Generic design assessment

UK EPR™ nuclear power plant design by AREVA NP SAS and Electricité de France SA

Final assessment report

**Aqueous radioactive waste
disposal and limits**

PCERsc3.4 Figure 1

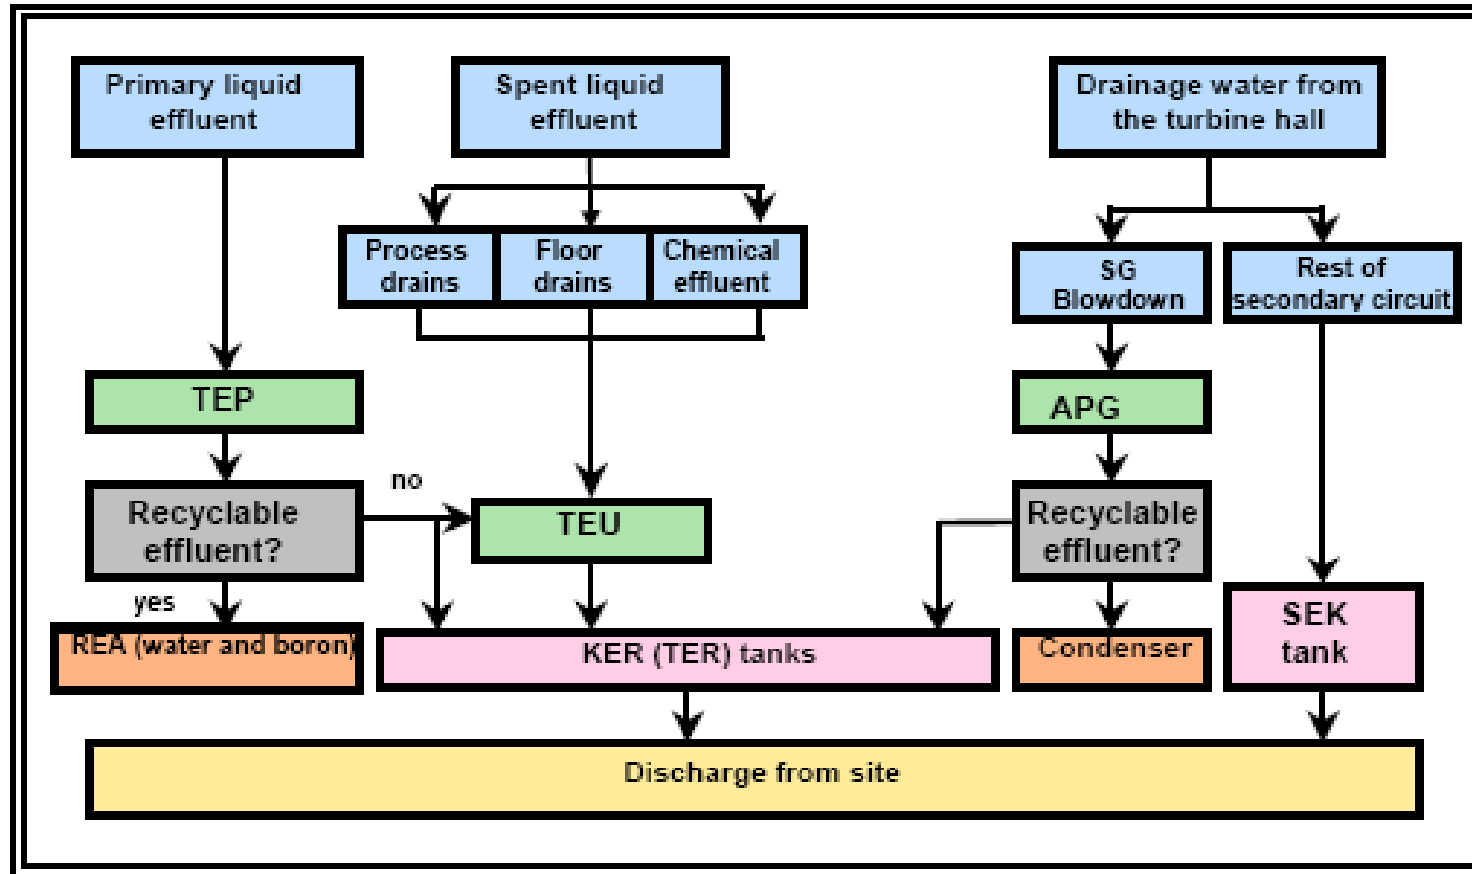
- 61 The PCERsc3.4s5.2.2 (see also Figure 1 reproduced in Annex 1 of this report) describes three categories of liquid radioactive effluent:
- a) liquid associated with the reactor coolant, not chemically polluted;

PCERsc6.4s1 Figure 1

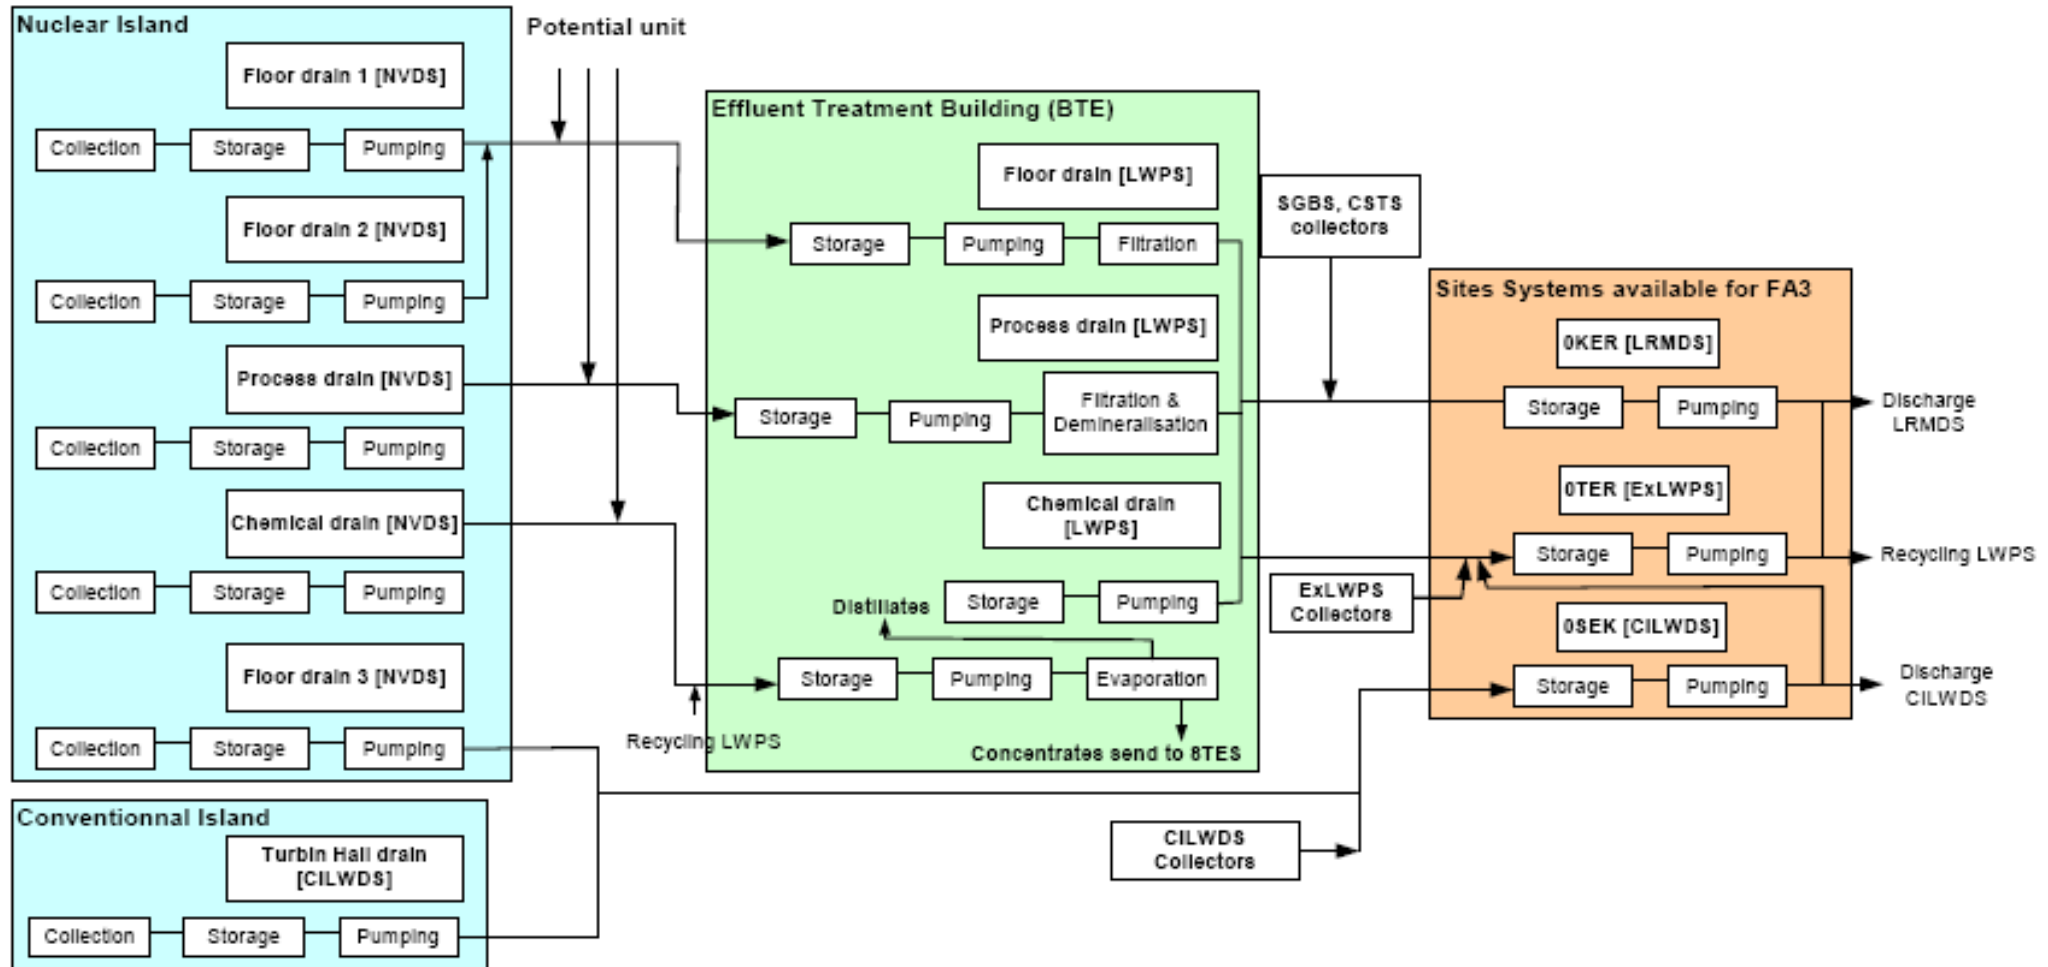
- 65 An overall diagram of the effluent systems is given in PCERsc6.4s1 Figure 1, reproduced in Annex 1 of this document.
- 66 The UK EPR uses filtration alone or combined with demineralisation and / or evaporation in the LWPS to minimise discharges of liquid radioactive waste. These techniques are specifically targeted at the reduction of fission and activation products and are assessed later in this report. PCERsc6.4s2.1 Figure 2, reproduced in Annex 1 of this report, shows the principle of routing of effluents.

IWS Figure 5

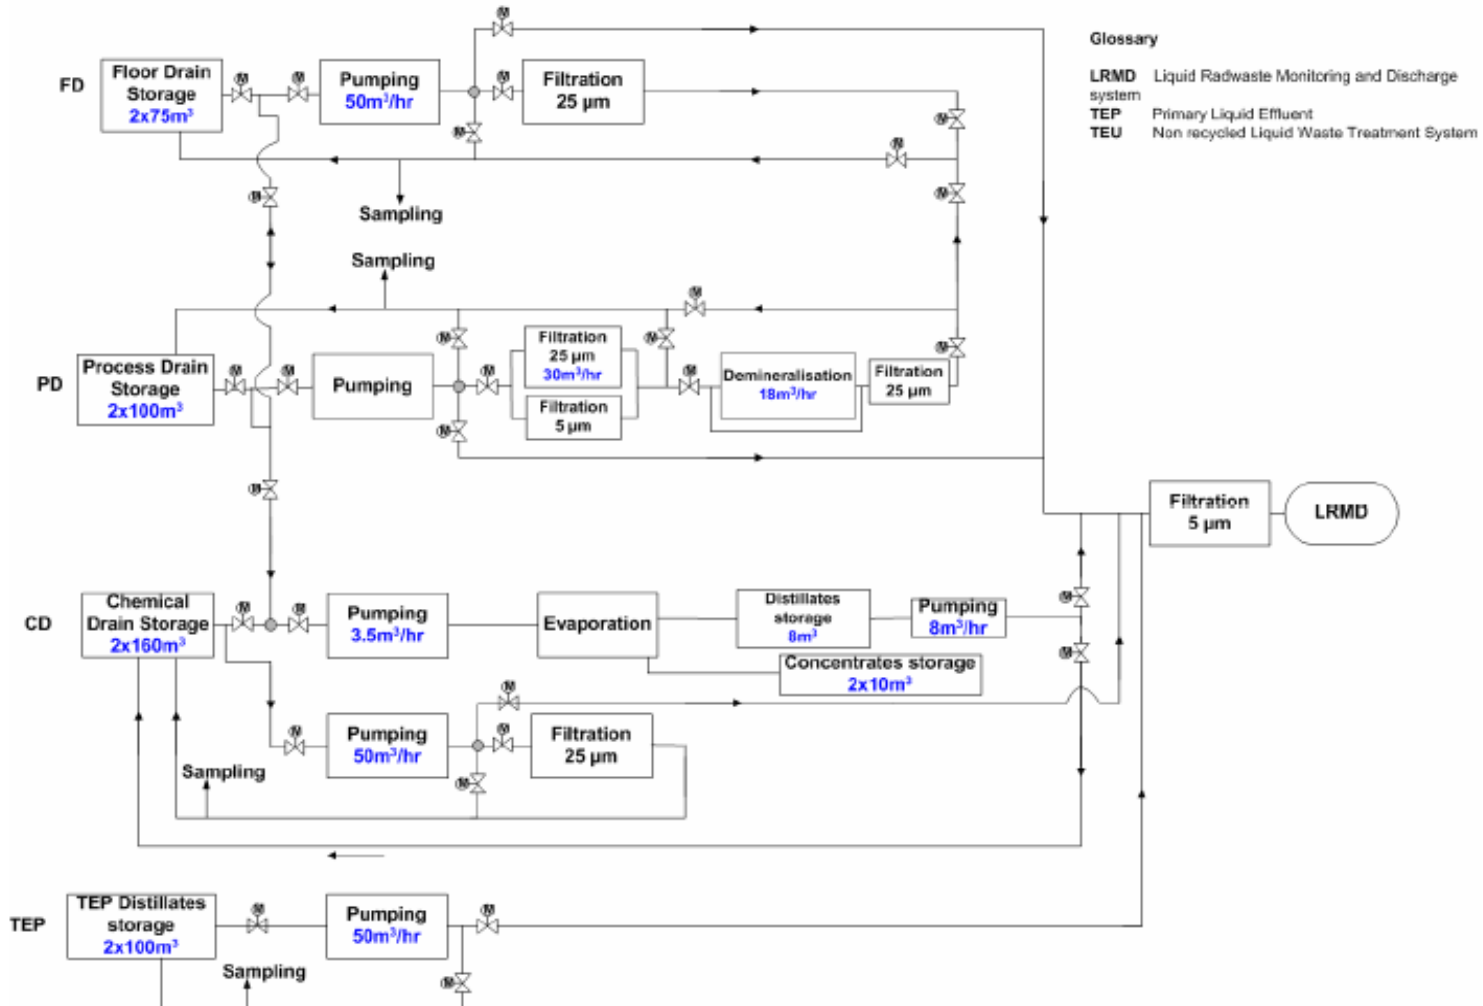
- [impact of aqueous discharges on the environment will be minimised, see our assessment finding UK EPR-AF08 later in this section.](#)
- 114 A diagram of the LWPS is provided as Figure 5 in the IWSp37 (reproduced in the Annex of this report) and more detailed descriptions are in PCERsc6.2s1.1.3.
